NO. SI 42NG-040

Austro Engine Mandatory Service Bulletin No. MSB-E4-007/3
ATA-Code: 71-00

No. MSB-E4-007/3
SUPERSEDES DOC. No. MSB-E4-007/2

Replacement of Waste Gate Controller

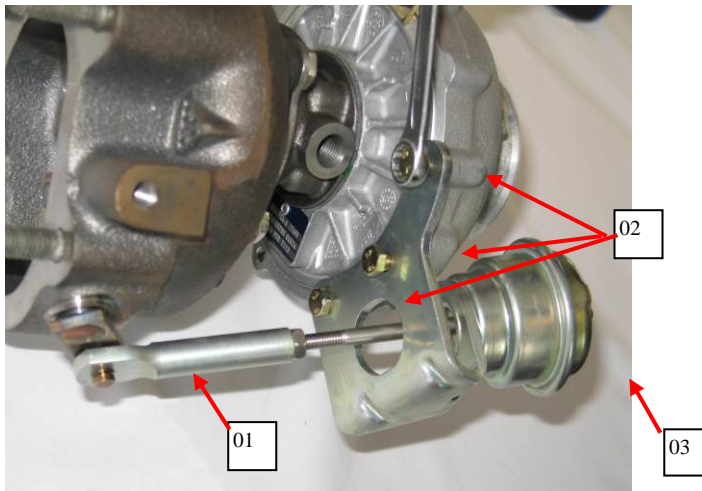
Removal of installed Waste Gate Controller:

1. Disconnect Hose at the top of the Waste Gate Controller
2. Remove three M6 Bolts [02]
3. Remove Circlip [01]
4. Disconnect rod from waste gate lever and remove waste gate controller [03]

Install new Waste Gate Controller according to table section 3.1

1. Install the three M6 Bolts [02] and torque them with 7 Nm
2. Attach external pump to the top of the Waste Gate Controller and apply pressure till the rod starts to move
3. Connect rod to waste gate lever
4. Adjust Waste Gate Controller according to Engine Maintenance Manual E4.08.04, Chapter 81-00-32.

Note: For fixing of the rod on the waste gate lever use new circlip.
